**CERTIFICATE OF APPROPRIATENESS**

**Property:** 2201 Lawrence Street, Lots 31 through 48, Block 53, Houston Heights Subdivision. The property includes a historic 107,279 square foot, two and four-story brick industrial structure situated on an 117,900 square foot corner lot.

**Proposal:** Alteration – Windows/Doors/ADA Ramp

**Recommendation:** **Approval with conditions: Retain the current pedestrian door, concrete header and transom on the south elevation if code enforcement does not require a taller opening for egress purposes. If it is required, approval of the proposed alteration.**

**SOUTH ELEVATION –FACING W 22<sup>ND</sup> STREET**  
EXISTING

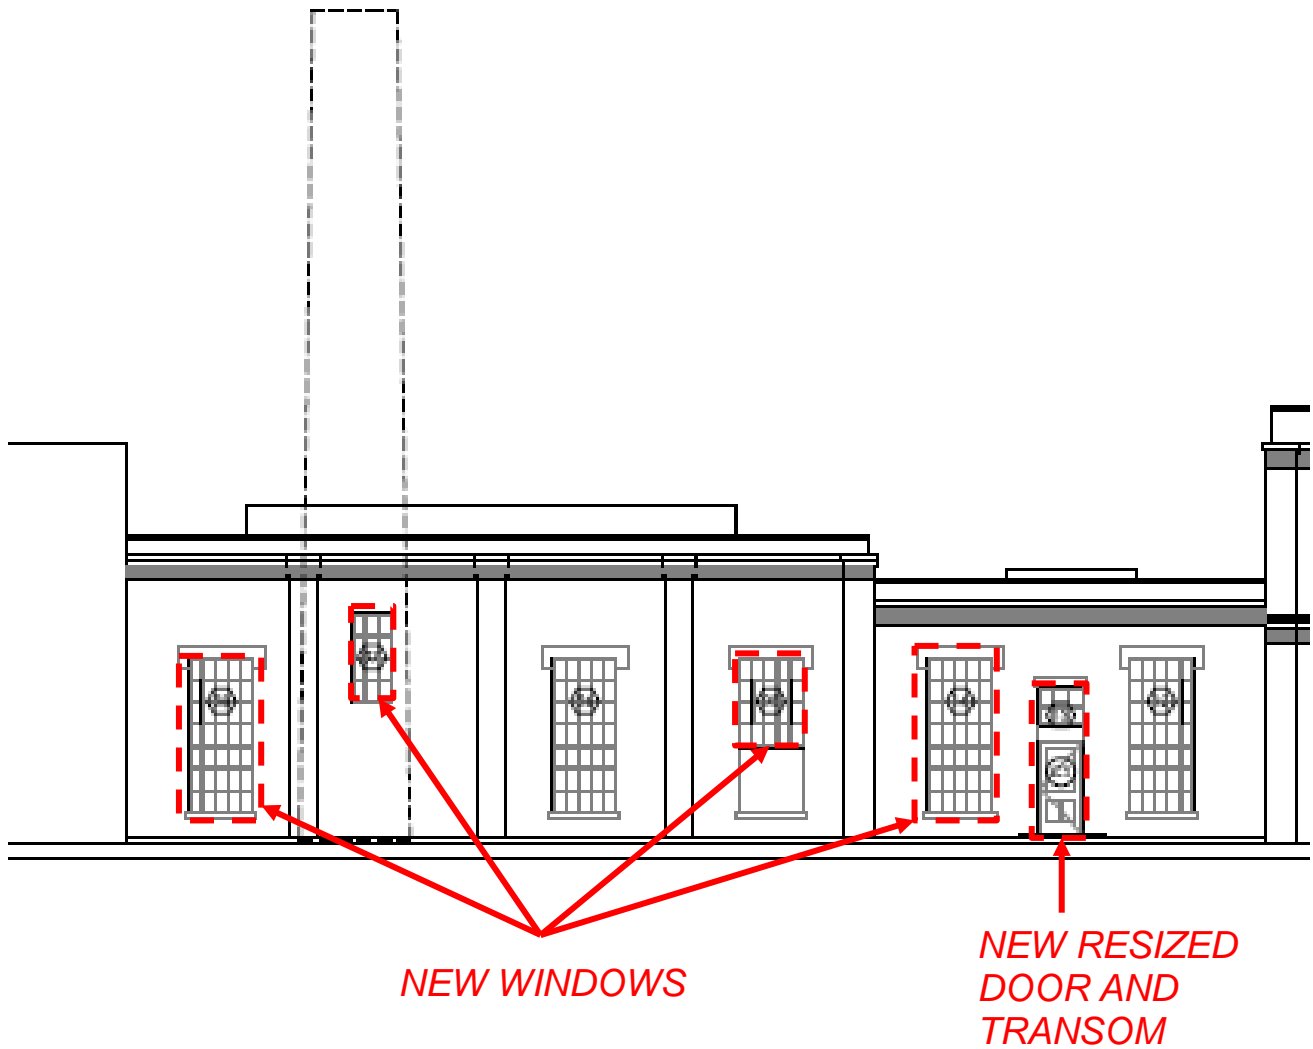
| <input checked="" type="checkbox"/> | <input type="checkbox"/> | <input type="checkbox"/>            | (1)                  | The proposed activity must retain and preserve the historical character of the property;<br><i>If code enforcement requires the door opening to be taller, the removal of the concrete header, door and bottom row of transom lites will meet this criteria since the opening of the door and the transom is not being altered.</i>  |                            |  |
| <input checked="" type="checkbox"/> | <input type="checkbox"/> | <input type="checkbox"/>            | (4)                  | The proposed activity must preserve the distinguishing qualities or character of the building, structure, object or site and its environment;<br><i>If code enforcement requires the door opening to be taller, the removal of the concrete header, door and bottom row of transom lites will meet this criteria since the opening of the door and the transom is not being altered.</i> |                            |  |
